**FLOODWAY DEVELOPMENT PERMIT #851-21-000003-PLNG &  
RIPARIAN EXCEPTION REQUEST #851-21-000327-PLNG:  
EMERIO DESIGN/POWELSON**

**ADMINISTRATIVE DECISION & STAFF REPORT**

**Decision Date: November 16, 2021**

**Decision: APPROVED WITH CONDITIONS  
(This is not Building or Placement Permit Approval)**

DATE: 08/28/2020  
REVISED: 02/24/2021  
(ADD EASEMENTS)

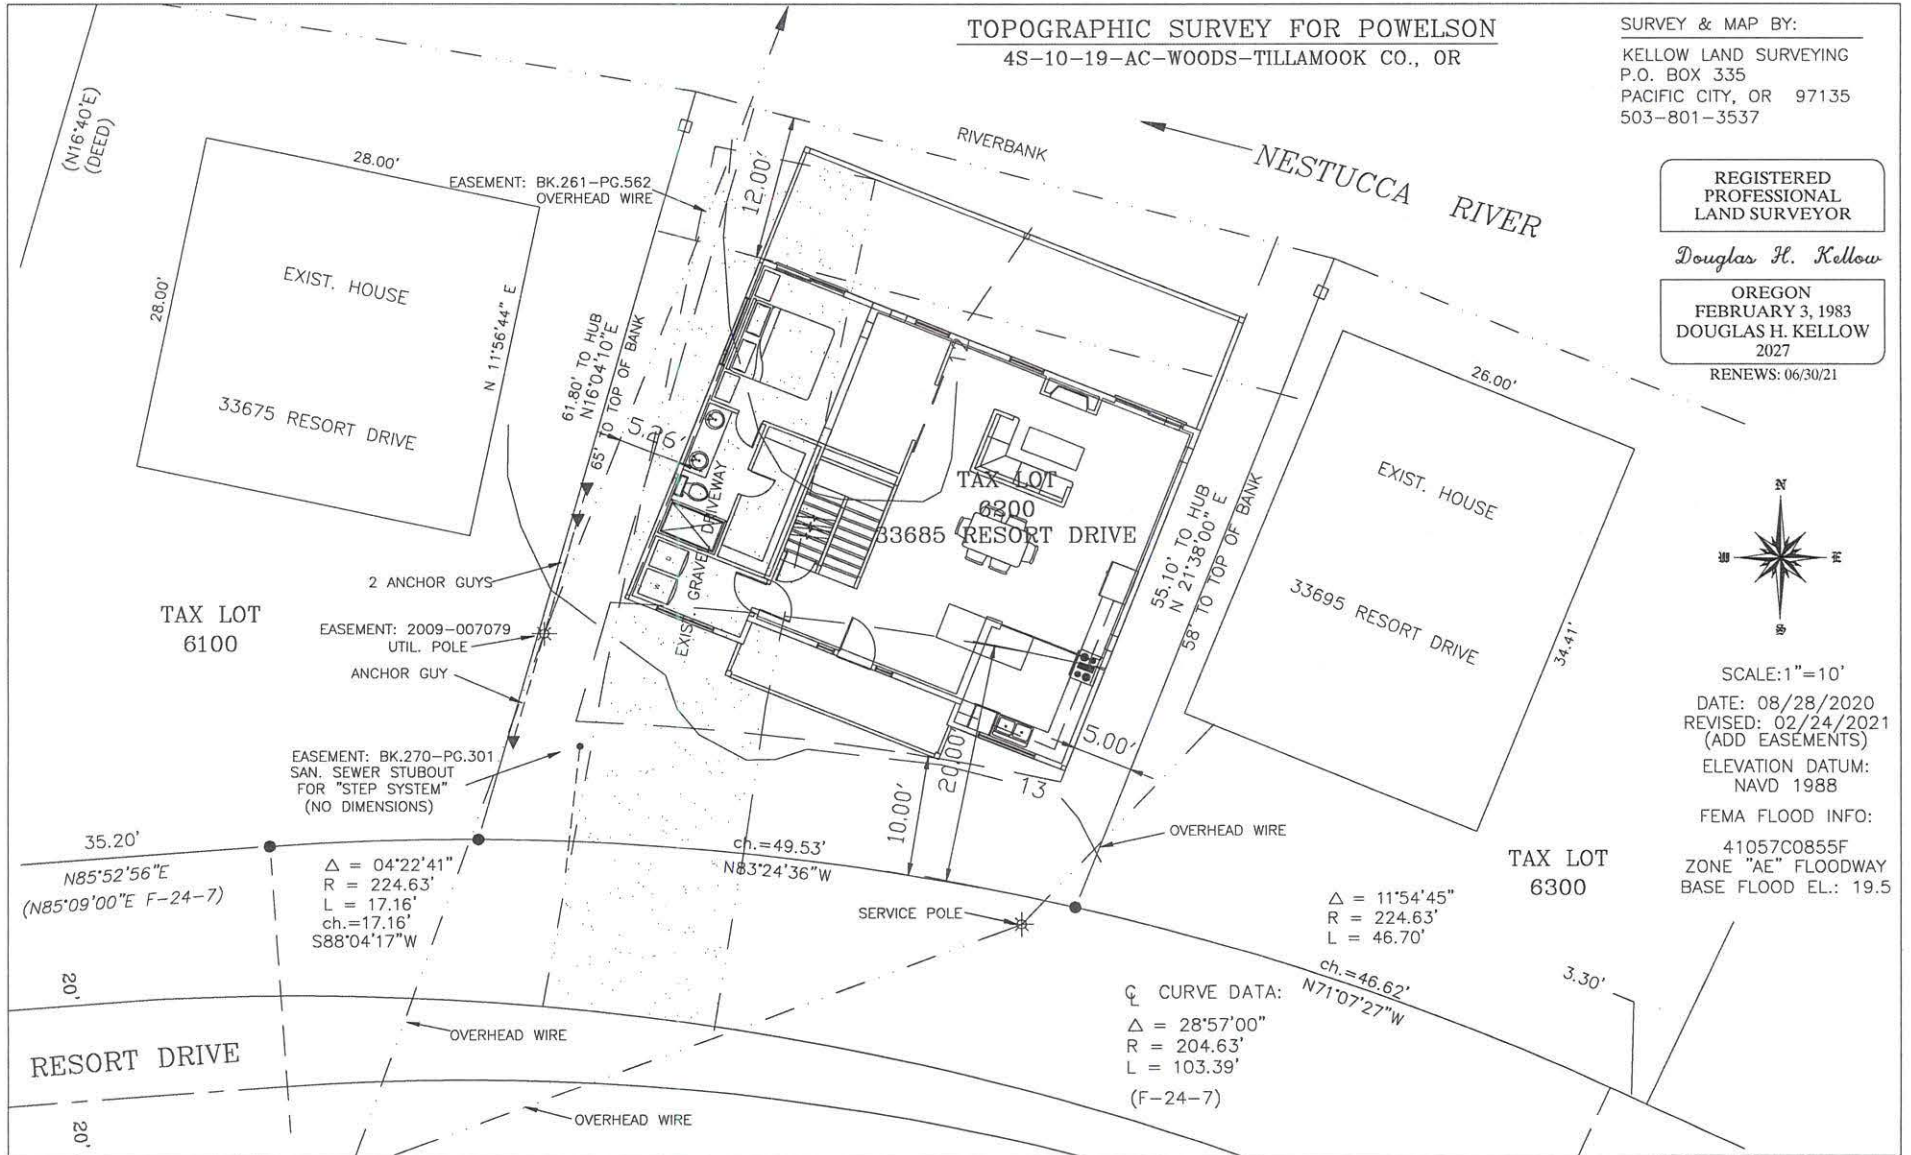
**Findings:** Applicant is proposing to construct a single-family dwelling (Exhibit B). A site plan was included in 'Exhibit B', which demonstrates that the proposed siting location is 8-feet from the riparian setback line. A letter was included from Robert Bradley, Oregon Department of Fish and Wildlife, recommended a 12-foot setback of the dwelling, with the second-story deck setback 8-feet from the riparian area (Exhibit B). The site plan indicates that the proposed siting location of the dwelling is landward of the Mean Higher High water (MHHW) and the line of non-aquatic vegetation.

**Findings:** The subject property abuts the Nestucca River, which defines the riparian area as 50-feet. Applicant is proposing to setback the proposed dwelling 12-feet from the riparian boundary with the deck maintaining an 8-foot setback, as determined by the Oregon Department of Fish and Wildlife (Exhibit B). Robert Bradley, ODFW, provided comments within the Applicants submittal that the setback reduction recommendation shall condition the planting of native trees and vegetation along the bank to provide further reduction to erosion potential (Exhibit B).

**Findings:** The Pacific City/Woods Unincorporated Community Area is a built and committed area as described in Goal 2 of the Tillamook County Comprehensive Plan. The subject property is approximately 60 to 65-feet in depth opposite the abutting riparian boundary (Exhibit A & B). Staff find the subject property abuts the Nestucca River which requires a 50-foot riparian setback. Therefore, TCLUO Section 4.140(3)(a)(i) would allow an exemption to the opposite yard of the riparian boundary to be reduced to 10-feet. Applicant has proposed a 10-foot front yard setback, opposite the riparian boundary (Exhibit B). Staff find this standard is met.

3. A minimum 12-foot riparian setback from the Nestucca River, determined by the Oregon Department of Fish and Wildlife (ODFW) and measured in accordance with TCLUO Section 4.140, shall be maintained on the subject property for the siting of the dwelling, with a minimum 8-foot riparian setback for the siting of an attached deck. Future development on the subject property shall also maintain the required riparian setback and comply with the requirements of TCLUO 4.140: Development Requirements for Water Quality and Streambank Stabilization.

5. The applicant/property owner shall submit a site plan drawn to scale that confirms all required setbacks are met. The site plan shall be submitted to the Department of Community Development at the time of consolidated Zoning and Building Permit application submittal.

FIGURE  
2

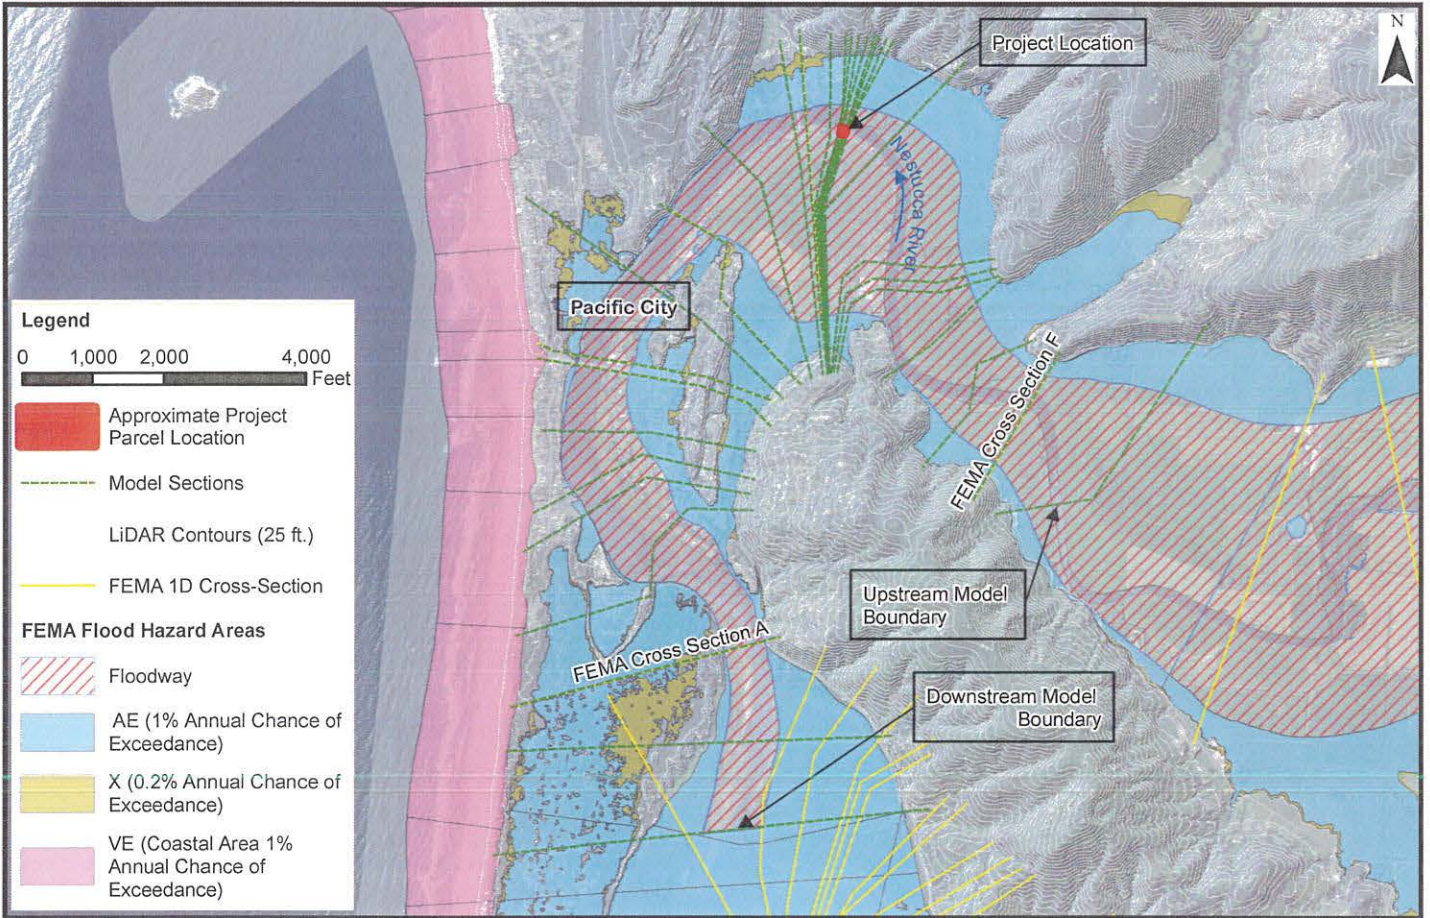
I received the following information, below, from my FEMA representative with regards to the Floodway information. Would you please provide this information to your hydrologist and have them correct their modeling? Mr. Crowley provided the correct modeling data that should be used, instead of that which your hydrologist used in their existing version.

Melissa – I am sorry to be have a different request than for my last review of a No-Rise Certification on the Nestucca River. I was not aware of this 2014 LOMR that updated the model for the Nestucca River downstream of Lettered Cross-Section F. This was Case Number 14-10-1727P and I believe was conducted by West Consultants. The effective model for this section of the river is available in HEC-RAS. Can you please provide this model to the applicant and ask them to include the proposed changes internal to his model? Lettered cross-sections A through F are identified in the geometric data. The HEC-RAS model is already in NAVD 88 (using a conversion of +3.38

Attached is the revised report addressing comments from the County. As expected, this didn't change the end result of the modeling and you should be good to resubmit.

Pacific City Beach house  
1st Floor Plan

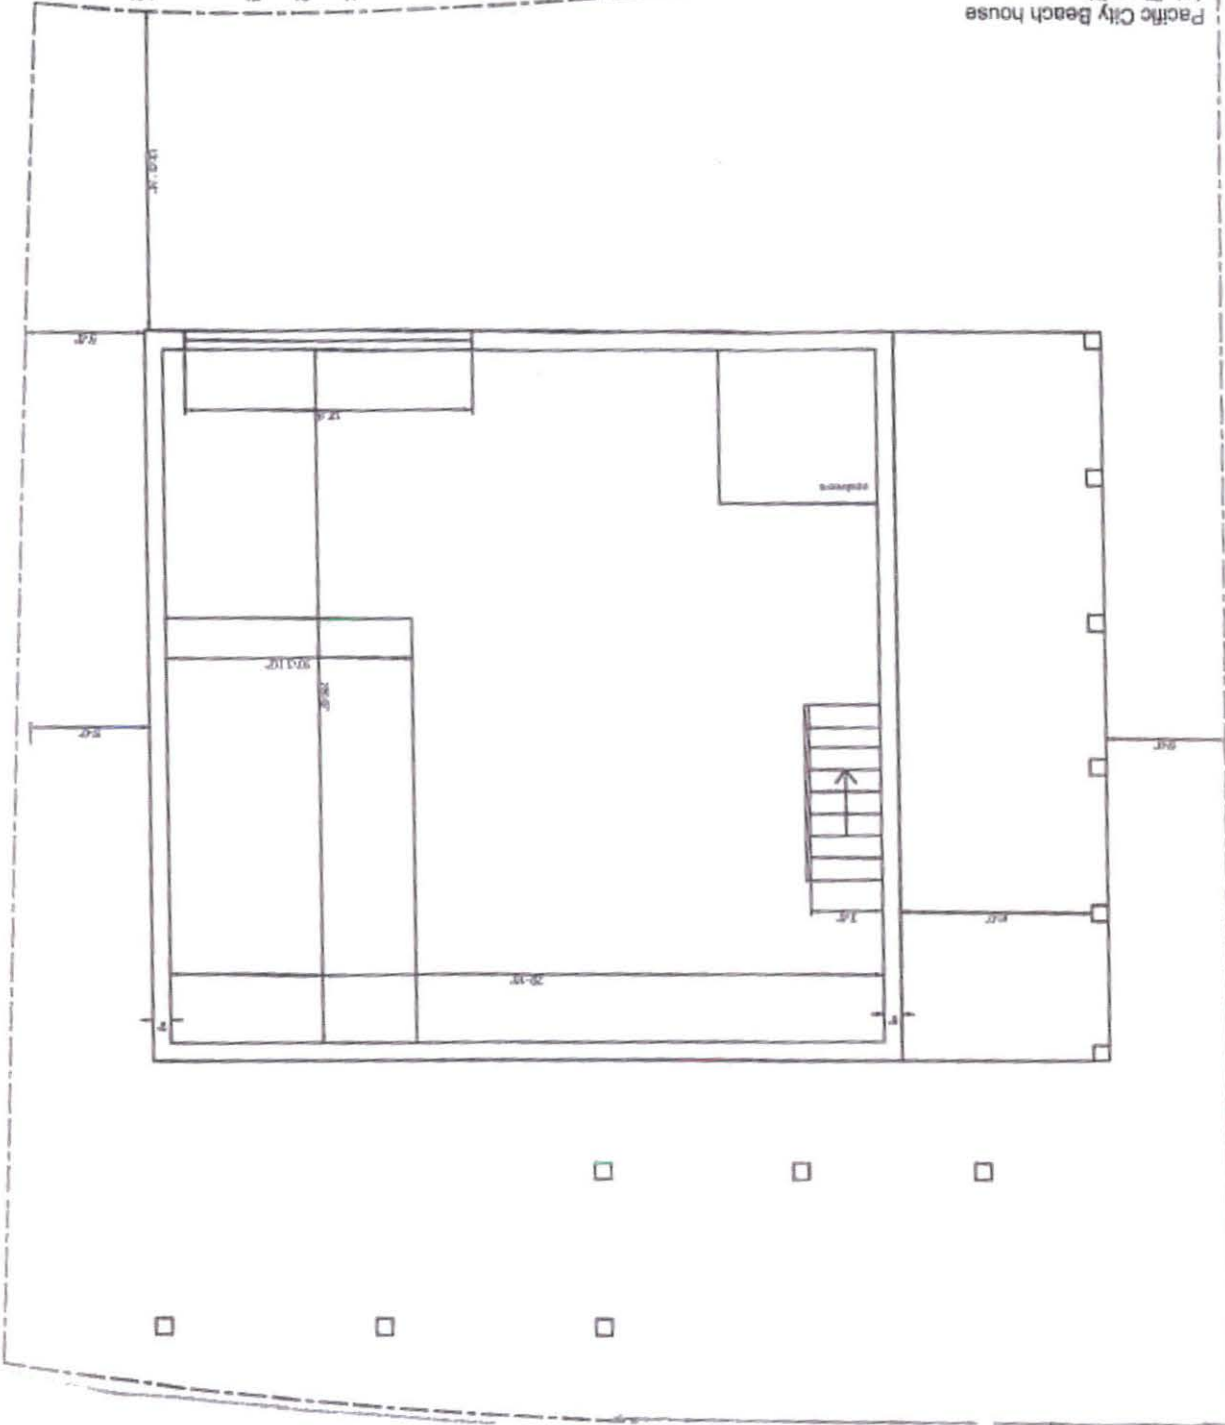
The proposed conditions model included the additional cross sections created in the existing conditions model. The existing conditions terrain was updated with proposed residential structure first floor footprint of 31 feet by 30 feet provided by design drawings supplied from the client (Figure 3). The proposed residential structure was modeled as a blocked obstruction at cross sections located at the upstream and downstream sides of the proposed building. The location of the proposed residential structure is approximate due to the surveyed property boundaries being in an arbitrary horizontal datum, but is considered accurate enough for the purposes of this analysis. Structural support posts for portions of the house above the first floor were not included in the model because these are assumed to have negligible effect on the river hydraulics (i.e. the river can flow unimpeded through these areas).
